MONTGOMERY COUNTY HISTORIC PRESERVATION COMMISSION
STAFF REPORT

Address:	30 Hesketh Street, Chevy Chase	Meeting Date:	5/22/2024
Resource:	Contributing Resource Chevy Chase Village Historic District	Report Date:	5/15/2024
Applicant:	Kristen Donoghue (Joe Heilman, Agent)	Public Notice:	5/8/2024
Review:	Historic Area Work Permit	Tax Credit:	n/a
Case Number:	1068788	Staff:	Dan Bruechert
Proposal:	Fence Installation

The applicant proposes to install a gate and construct a trash enclosure.

A GARDEN GATE
Scale: 1/2" = 1'-0"

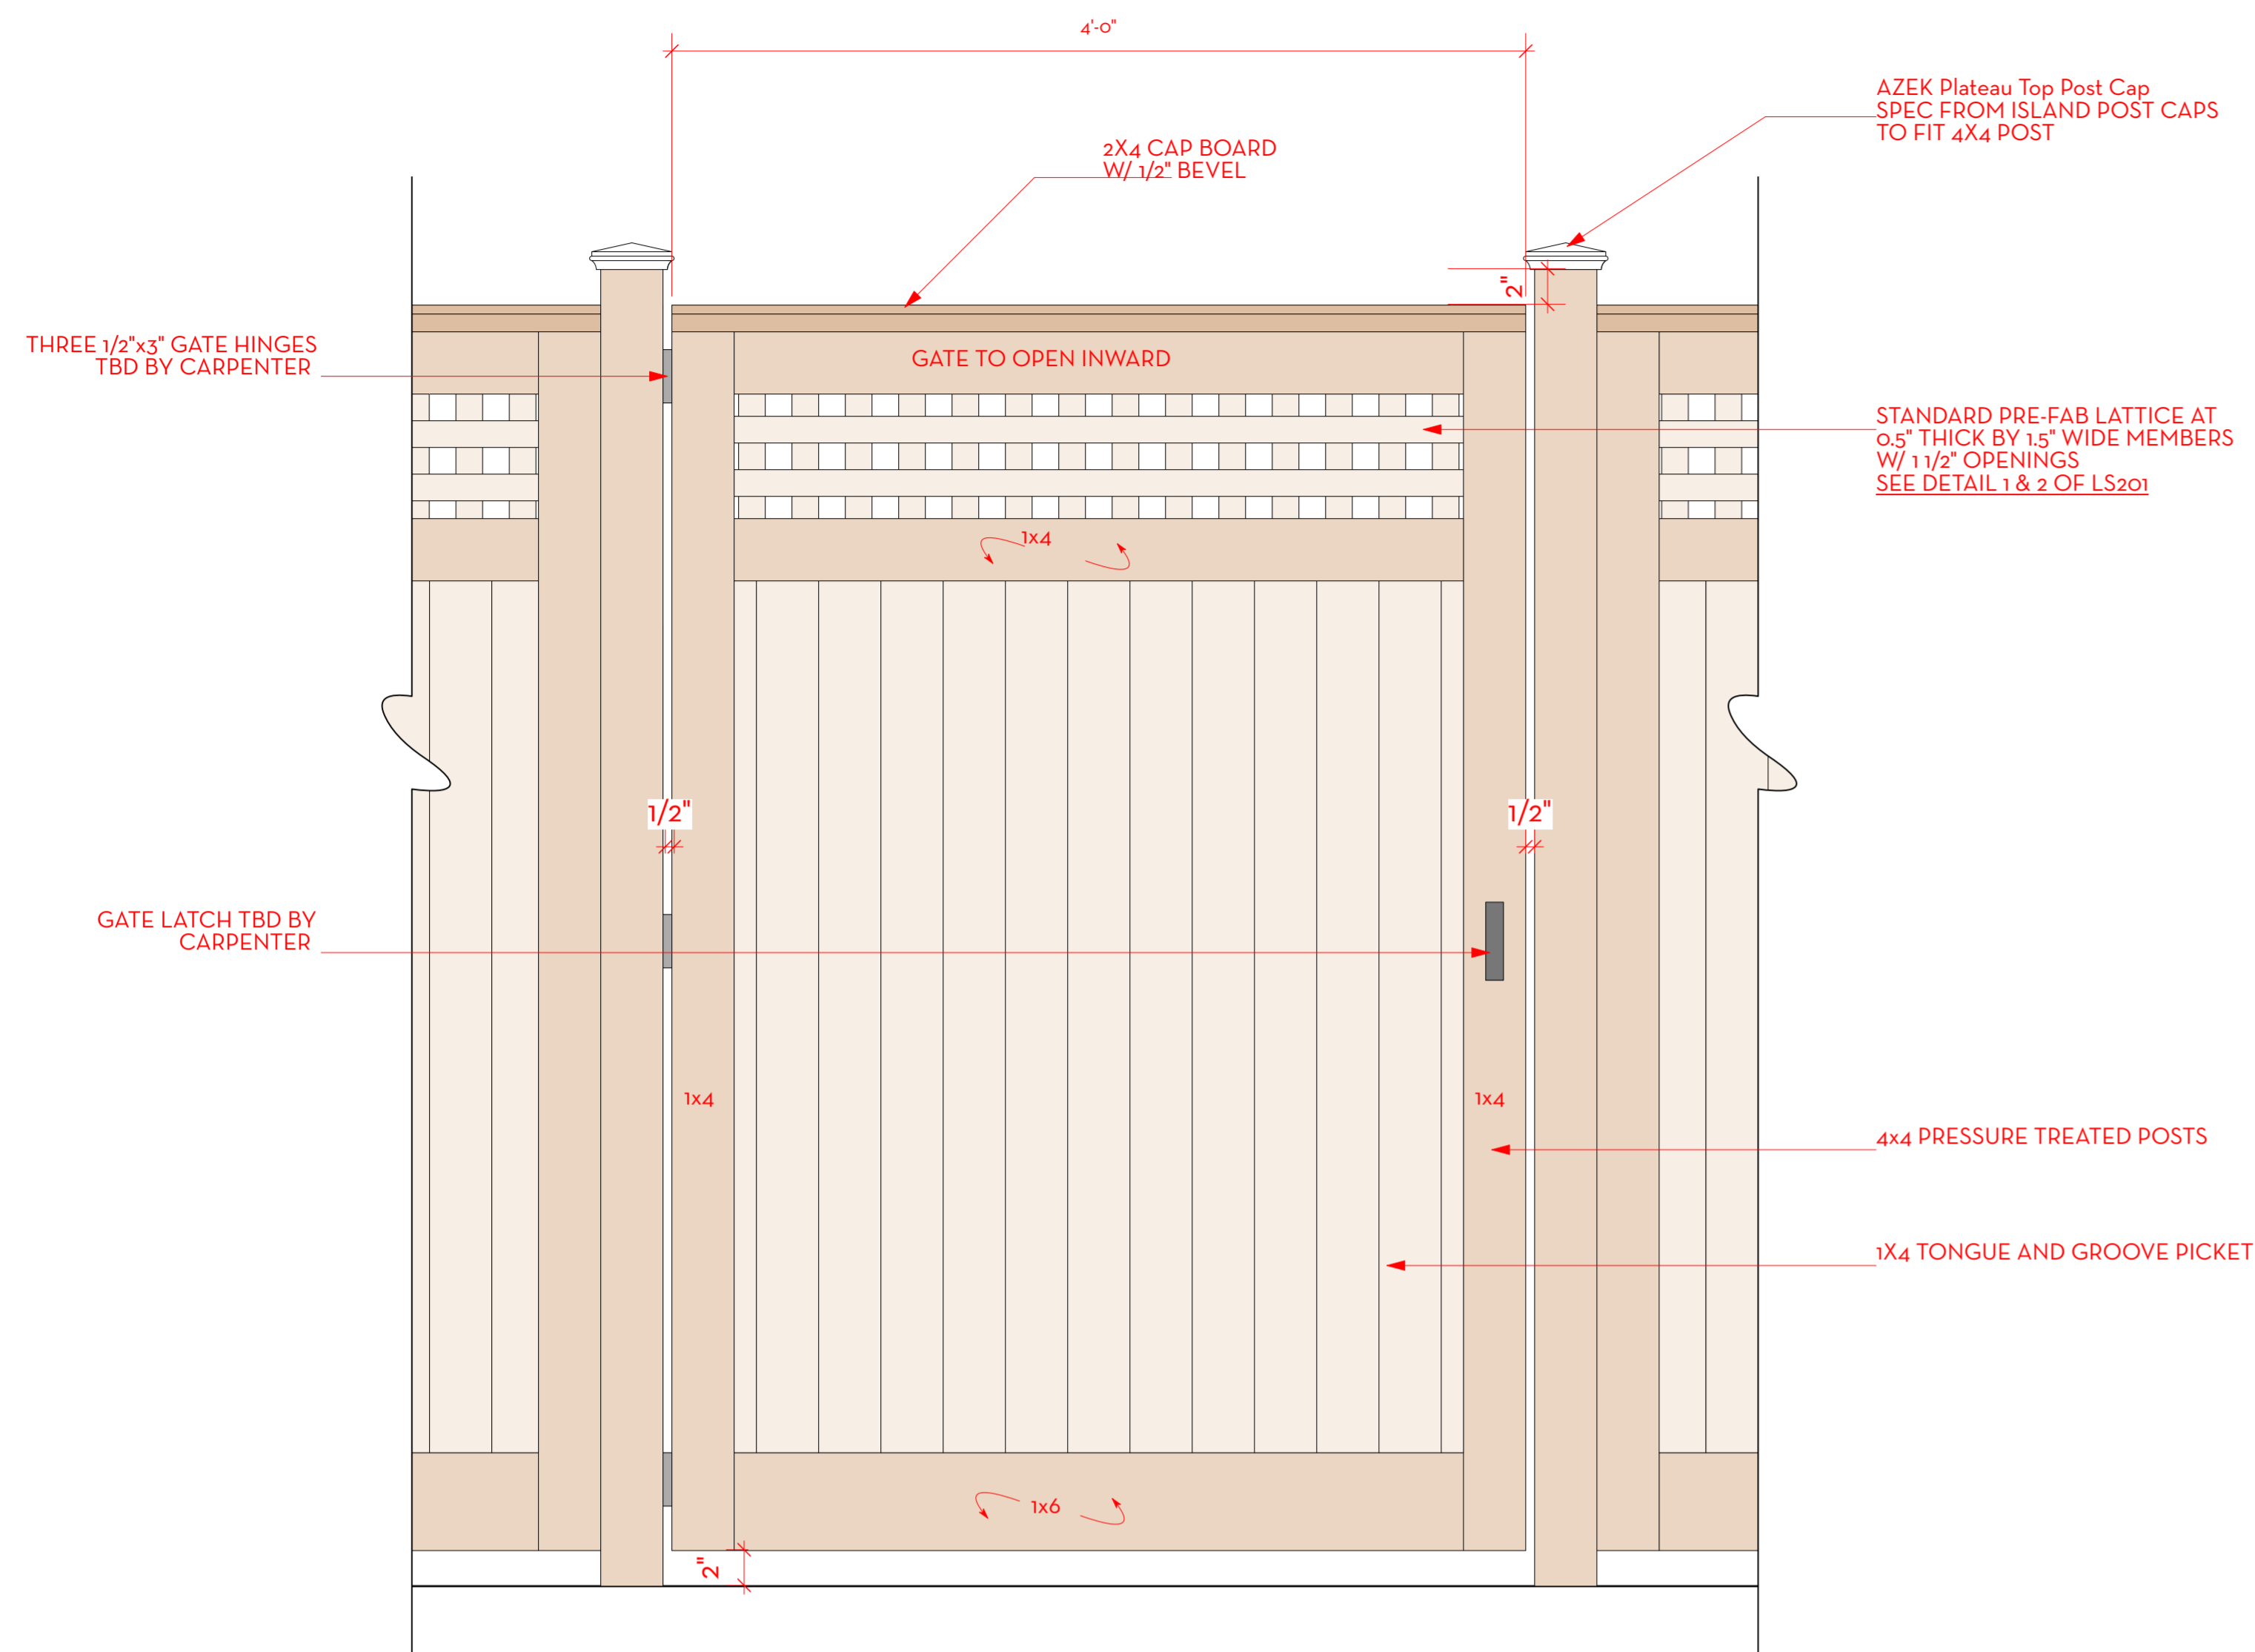
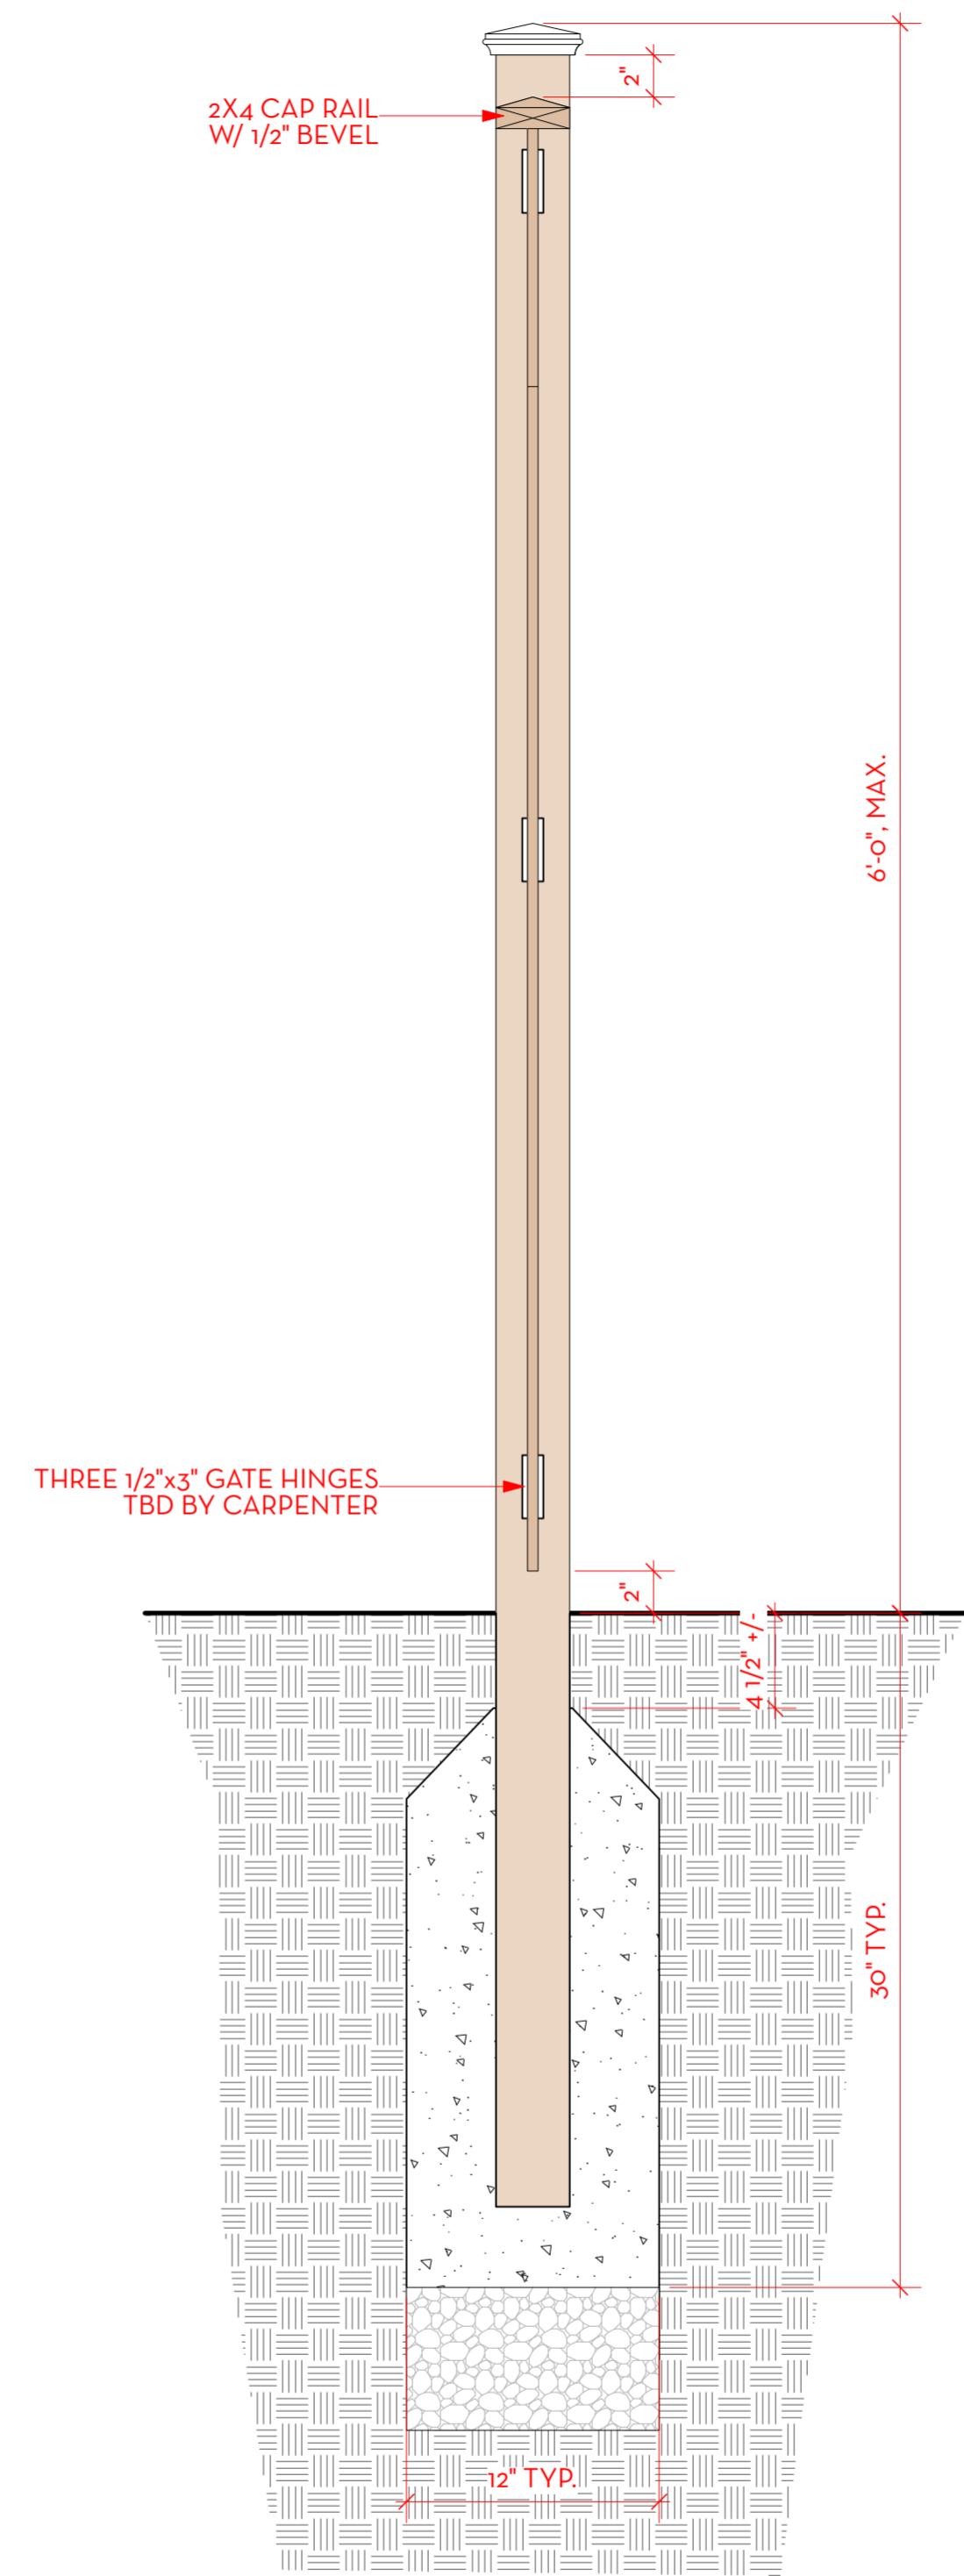
The second proposed change is a gate along the east property line (the project narrative says 'west'). The gate is 6' (six feet) tall and will match the trash/HVAC enclosure's design and materials. Typically, fences in front of the historic rear wall plane are limited to 48" (forty-eight inches) tall and must have an open picket design. These characteristics help to preserve the sense of openness and the district's overall park-like setting. However, this setting is unique because the house does not reinforce the street front pattern along Hesketh St., which creates a very narrow side setback and narrows to the south (see *Figure 2*, below). Because of this unique setting, Staff finds the proposed fence is compatible and will not detract from either the district's park-like setting or its sense of openness and Staff recommends the HPC approve the gate under the *Design Guidelines* and 24A-8(b)(2) and (d).
